City of Columbia

Re: Landmark Subdivision-Plat 3 - Final minor plat, Sidewalk variance (Case #15-174)

**AGENDA REPORT
PLANNING AND ZONING COMMISSION MEETING
August 20, 2015**

FINAL REPEAT OF A MINOR SUBDIVISION
LANDMARK SUBDIVISION - PLAT 3
CITY OF COLUMBIA, BOONE COUNTY, MISSOURI
AUGUST 11, 2015

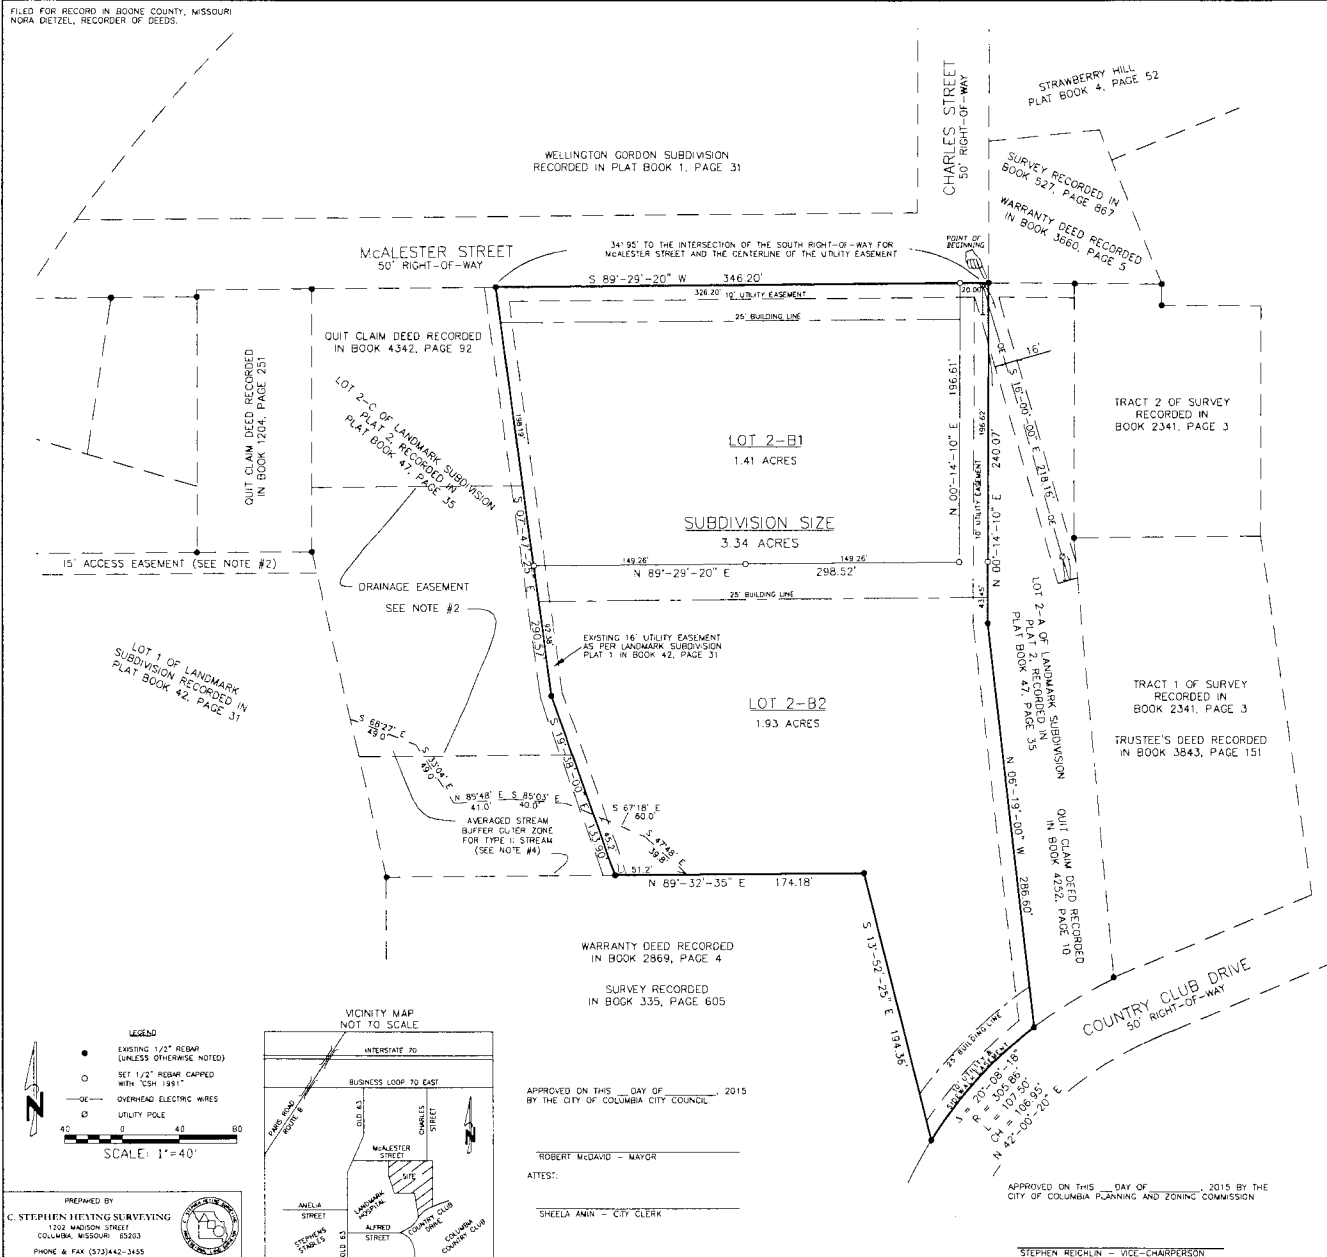
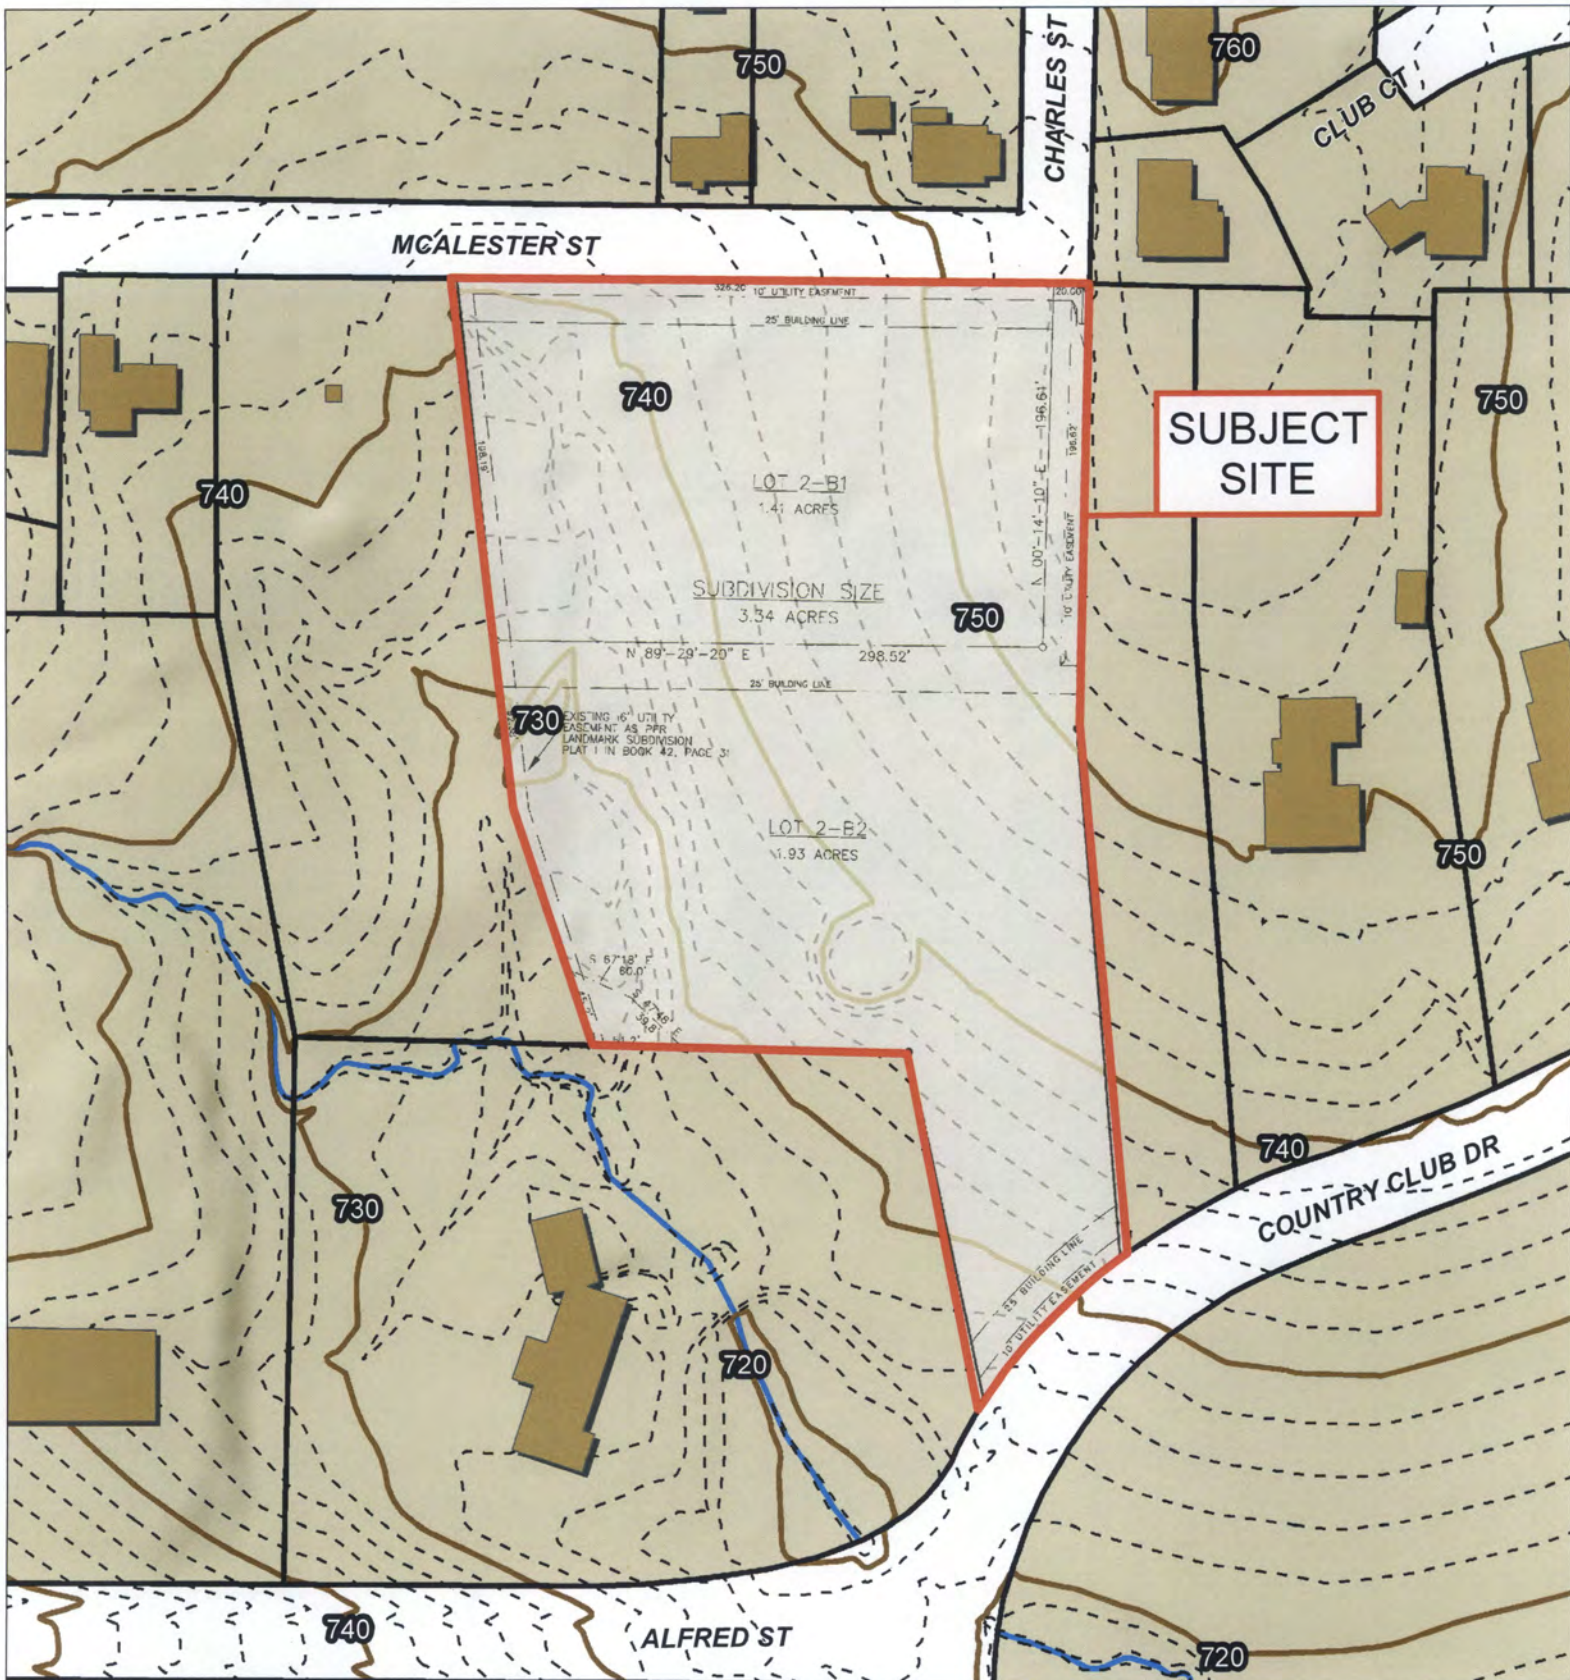
After consideration of the requested variance to Section 25-48.1, staff finds that the listed factors included in Council Policy Resolution 48-06A are not adequately supported for staff to recommend approval of the requested variance. In staff's assessment, the applicant has met standards #3 and #4. Regarding standard #2, sidewalks are feasible, but construction could impact the existing drainage, which is not optimal. Clearly, the cost of constructing the sidewalk represents a small portion of the overall cost of the project, so standard #1 is not met.

As previously stated, Council granted a sidewalk variance for virtually the same property when it approved Landmark Subdivision Plat 2. Staff did not support the previous request either, and conditions do not appear to have changed since that time. While recommending that the variance be denied, staff acknowledges that it is unlikely that additional sidewalk will be constructed in the vicinity of the subject property, enabling a connection to a wider sidewalk network. However, in order for staff to

The Public Works Department does not object to the variance being granted, but does recommend a ten-foot sidewalk easement, located along the southern property line, be granted to the City in order to allow the City the ability to construct the sidewalk in the future if it so chooses. If the Commission considers granting the variance, staff recommends including the easement as a condition of approval. If not granted, the City may be required to purchase the easements from the property owner in the event that the City installs sidewalks in the future. Staff believes this is a reasonable condition in order to avoid the City becoming responsible for not only the installation of the sidewalk, but also the cost of easements that would have been the responsibility of the owner had a variance not been granted.

Staff has reviewed the submitted final plat and finds that the plat meets all technical requirements of the City's Subdivision Regulations. Staff supports the approval of the final plat, but does not support the approval of the requested variance.

Approval of the final plat of "Landmark Subdivision - Plat 3".
